# Access Compliance Report

## Public Rights-of-Way

### (Curb Ramps)

Intersection ID: 10033070	Main Street: NORTH_COMMUNITY_HOUSE_RD	Cross Street: N/A	Location: SE
ADA ID: 1FAECC958B67	Ramp Type: Perp	Initial Pass/Fail: Fail	Overall Compliance: No
		Severity Score: 8.75	
Codes/Mitigation Info/Possible Solution		Field Measurements/Component Compliance

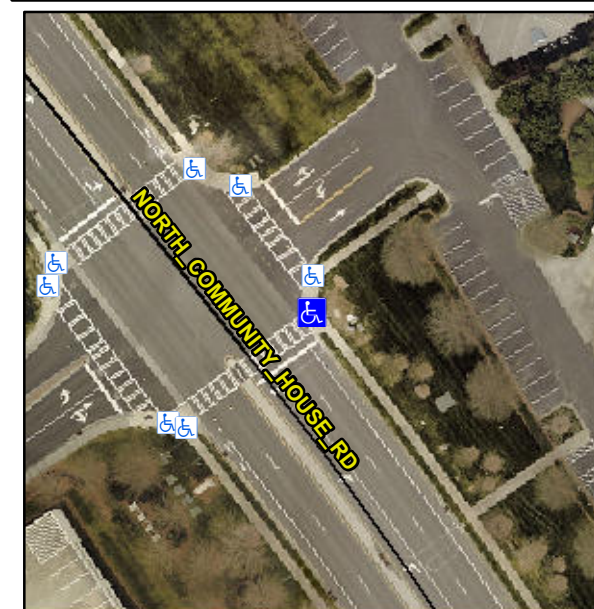
**R304.5.1**

Compliance	Description	Data	Compliance	Description	Data
N/A	Ramp Length (in)	87.5	Yes	Ramp Slope (%)	7.4
No	Ramp Width (in)	46.5	Yes	Ramp XSlope (%)	1.5
N/A	Flare Type LT	N/A	N/A	Flare Type RT	N/A
N/A	Flare Slope LT (%)	N/A	N/A	Flare Slope RT (%)	N/A
N/A	Flare Traversable LT?	N/A	N/A	Flare Traversable RT?	N/A
N/A	Landing Length (in)	N/A	N/A	DWS Provided?	N/A
N/A	Landing Width (in)	N/A	N/A	DWS Contrast?	N/A
N/A	Landing Slope (%)	N/A	N/A	DWS Length (in)	N/A
N/A	Landing X Slope (%)	N/A	N/A	DWS Full Width?	N/A
N/A	Landing Curb? (Y/N)	N/A	N/A	DWS Offset (in)	N/A
N/A	Shared Landing?	N/A			
N/A	Gutter Ponding?	N/A	N/A	Gutter Slope (%)	N/A
N/A	Gutter Lip Ht (in)	N/A	N/A	Gutter X Slope (%)	N/A
N/A	Painted X Walk1?	Yes	N/A	Painted X Walk2?	N/A
	X Walk 1 Direction	To SW		X Walk 2 Direction	N/A
N/A	X Walk 1 Width (in)	127.0	N/A	X Walk 2 Width (in)	N/A
	X Walk 1 Slope (%)	3.1		X Walk 2 Slope (%)	N/A
	X Walk 1 X Slope (%)	1.6		X Walk 2 X Slope (%)	N/A

**Remove & Replace Entire Ramp.**
